CS Memorandum No. 1471

Subject: Configuration Management Board Meeting No. 128

CMB Meeting Minutes #128

SUBJECT: Configuration Management Board Meeting # 128 – Rev. No. 0

CONTRACT NO. 1254R	
SFMTA CONTROL NO. CL-19572	
DRAWING NO. LA-100	REVISION
SHEET NO. 105	1

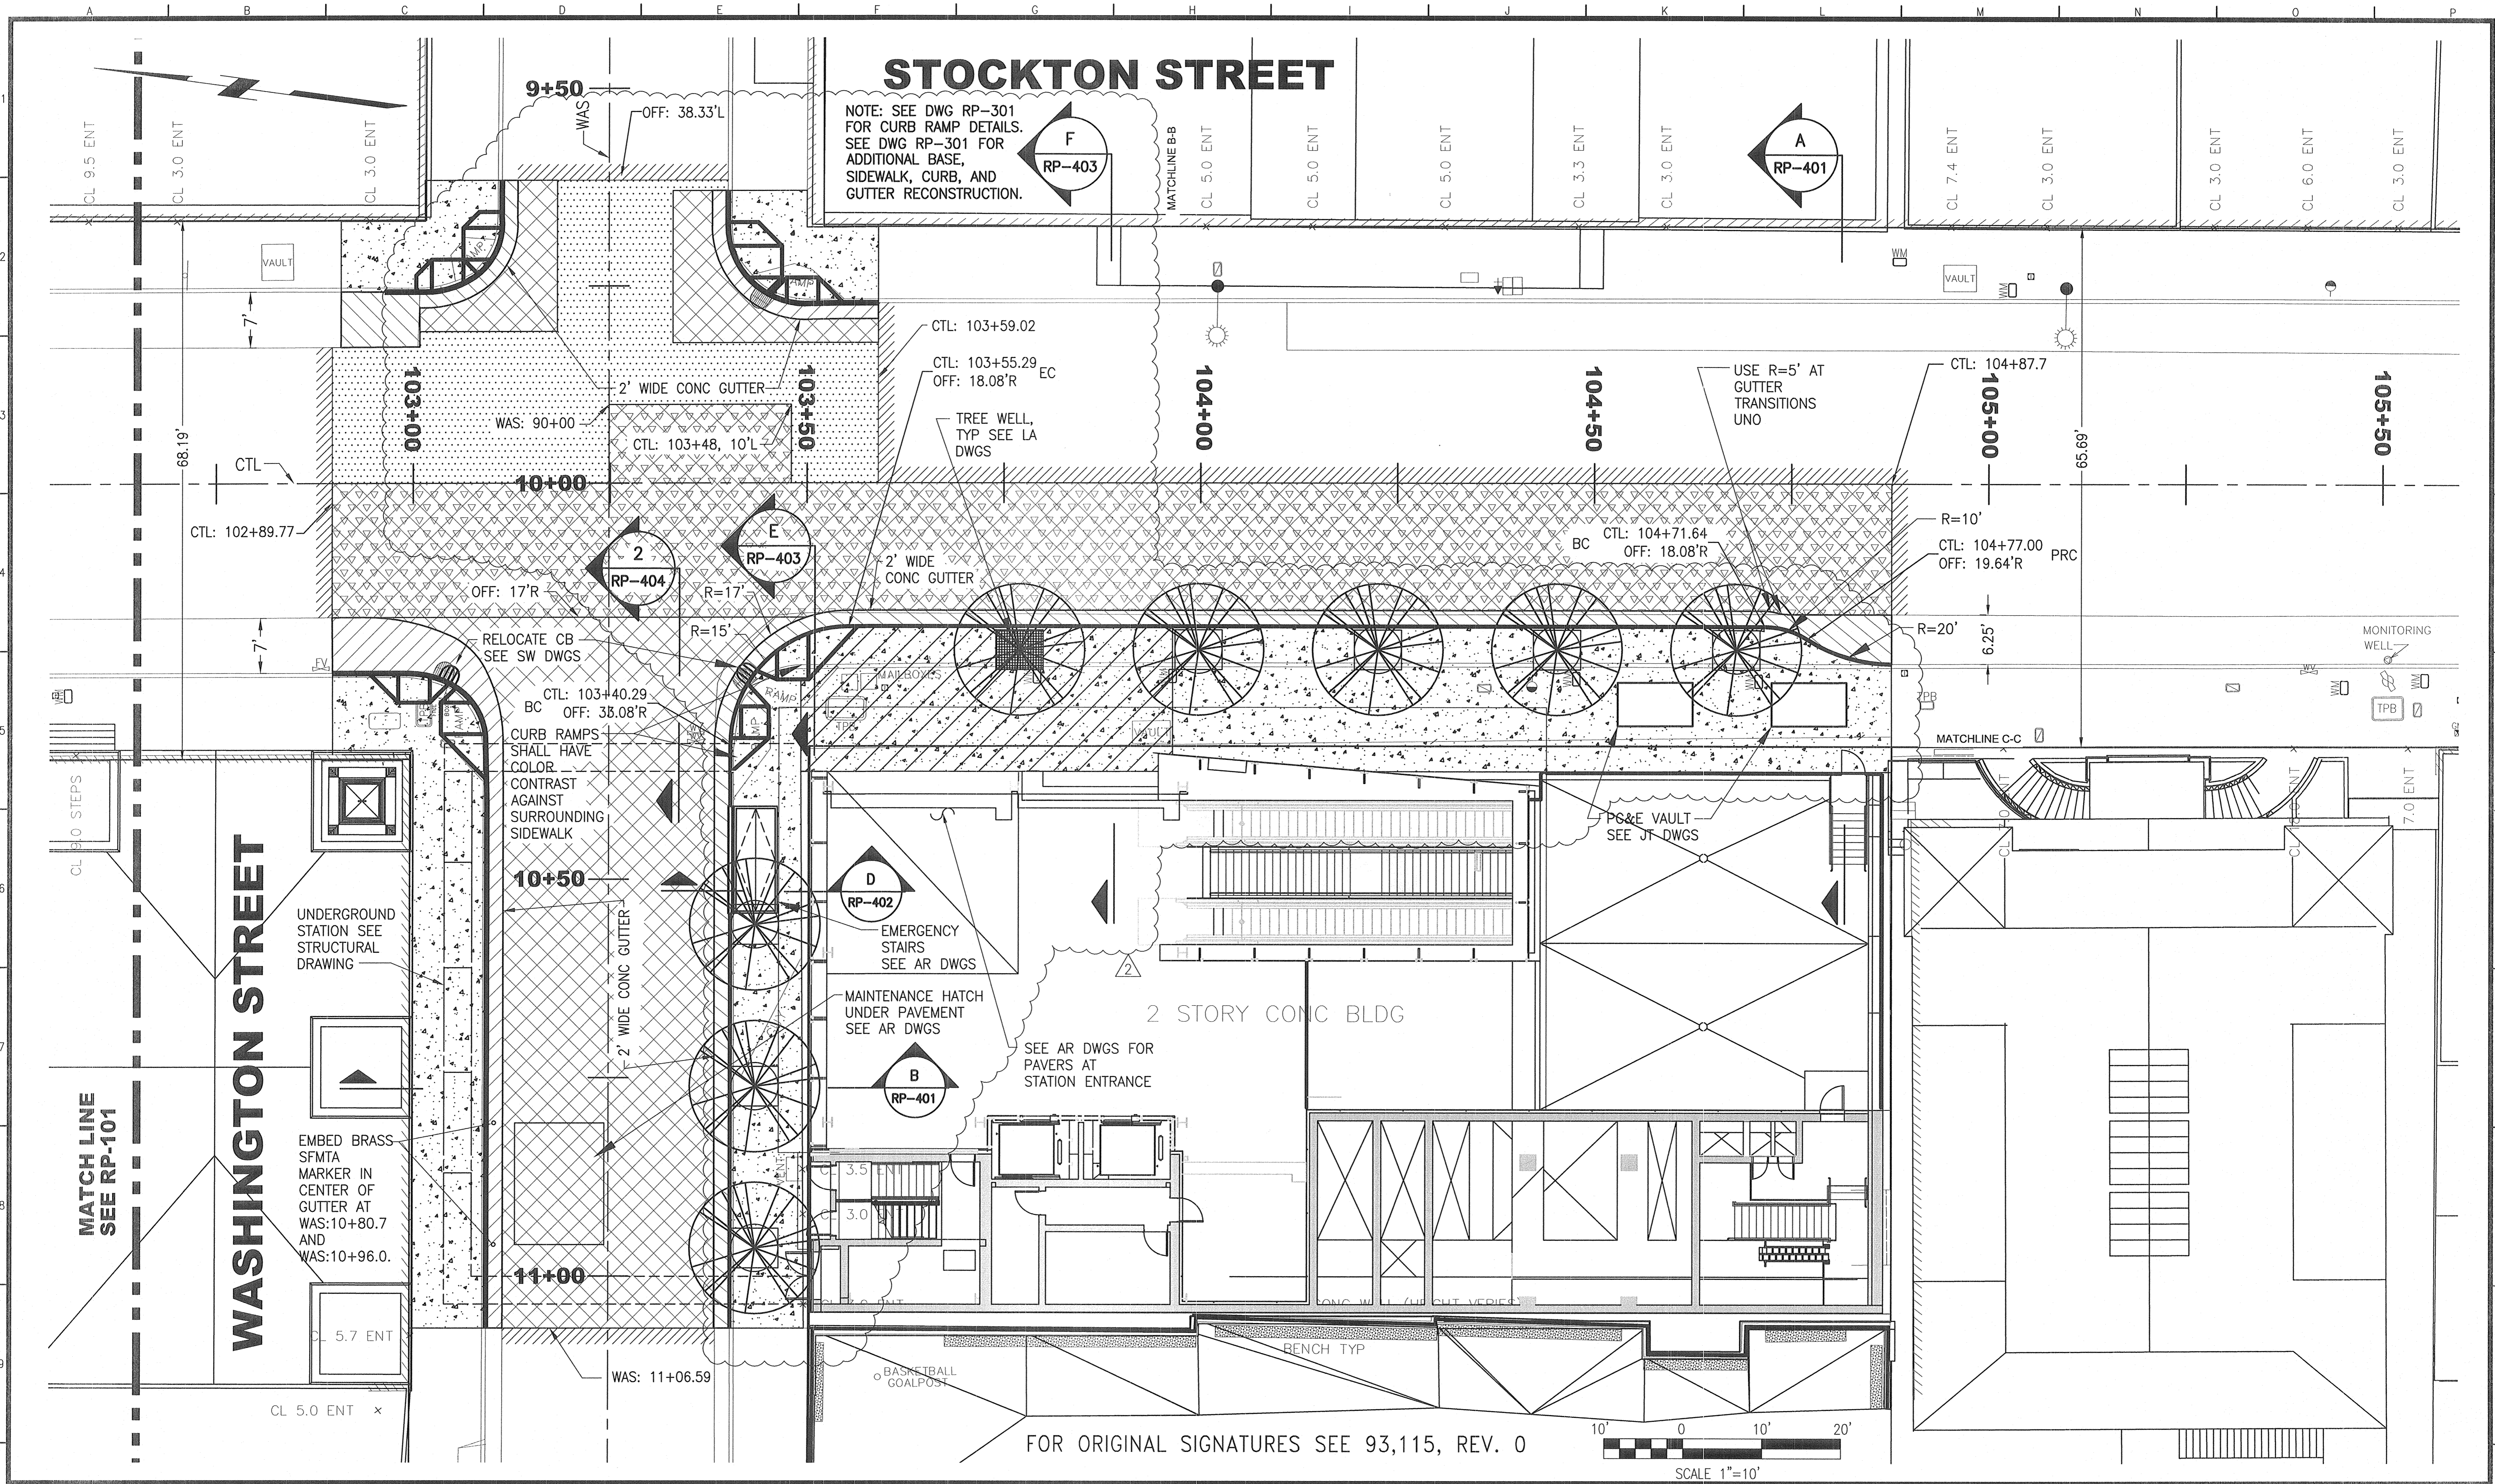
Approved for Distribution By Discipline Lead: Charu Sharma, Miles Stevens Architect (LA)	Date: 6/5/13	Signature: 
Comments: Additional trees (including coordination with architect) were incorporated via addendum. Any revisions to accommodate bus stop would need to be addressed via construction change order		
Change Recommended: Yes <input checked="" type="checkbox"/> No <input type="checkbox"/>
